Our Case Number: ABP-318446-23

Re: Proposed construction of Coumnagappul Wind Farm consisting of 10 no. turbines and associated infrastructure.

Strategic Infrastructure Development Coumnagappul Wind Farm Case No: 318446 An Bórd Pleanála 64 Marlborough Street Dublin D01V902.

Height of Turbines:

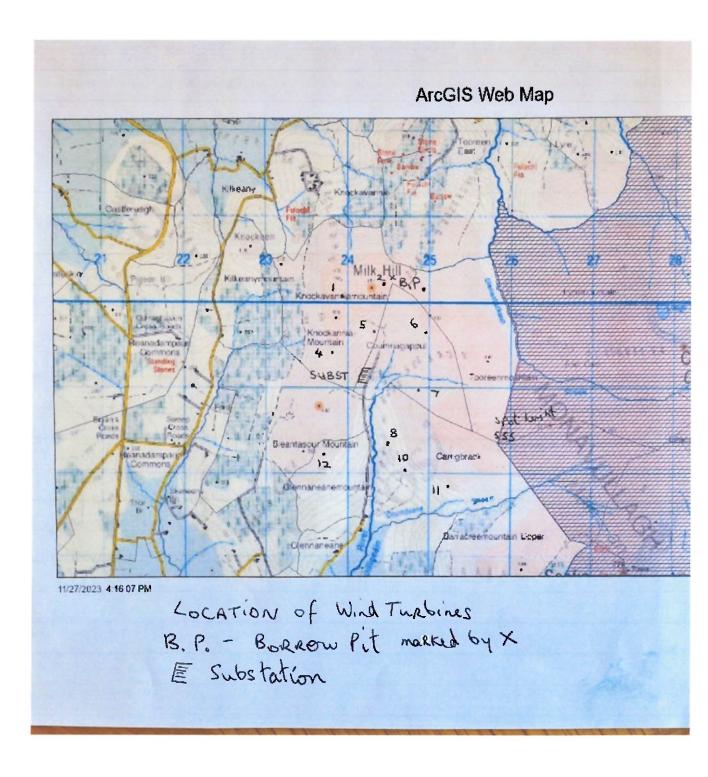
Four of the ten turbines here start at an elevation of about 400 metres or above. Add on their 185 metres height and you have **a final height of almost 600 metres** - T1, T2, T4, T6. If we compare the Coumnagappul project to the controversial Derrybrien one – the turbines in Derrybrien were 75 metres high, less than half that of the Coumnagappul ones.

The Gap:

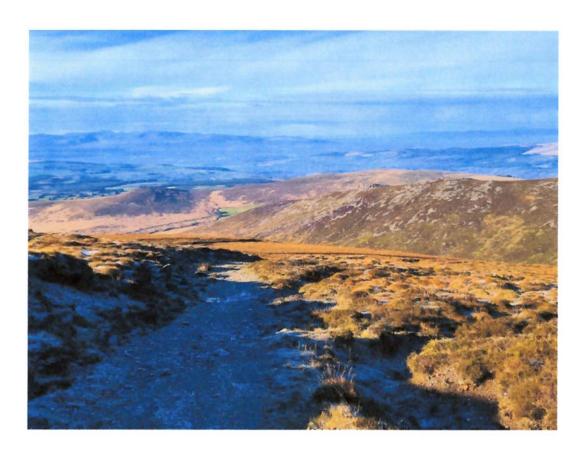
The Gap, at 466 metres elevation, is the highest pass in Waterford. Sitting at the head of the Nire Valley, and central point of the old Bóithrín na Sochraide (funeral path) from the Nire to Rathgormack, it affords fine views down along its length. These views will be compromised by the turbines on Milk Hill.

(see photo above, looking north along Tooreen Mountain towards the low plateau of Milk Hill in centre background). Although it reaches just 450 metres elevation, Milk Hill has one of the finest panoramas in west Waterford – Knockmealdowns and Galtees to the west, Boolabrien Ridge, Lachtnafrankee and Slievenamon to the north, Knockanaffrin Ridge, the Gap, the Nire Valley and its coums to the north-east and east, the Comeragh Plateau, the high Monavullagh ridges, Seefin and Crohaun to the south. Two turbines, **T1 and T2**, will stand on its summit at over 400 metres elevation. As mentioned already, these **will tower above the picturesque Nire Valley** to the north-east. All the other turbines will rise high into the sky above any hillwalker who looks south across Coumnagappul Valley towards the Comeragh Plateau and high Monavullaghs. **Absolute landscape vandalism.**
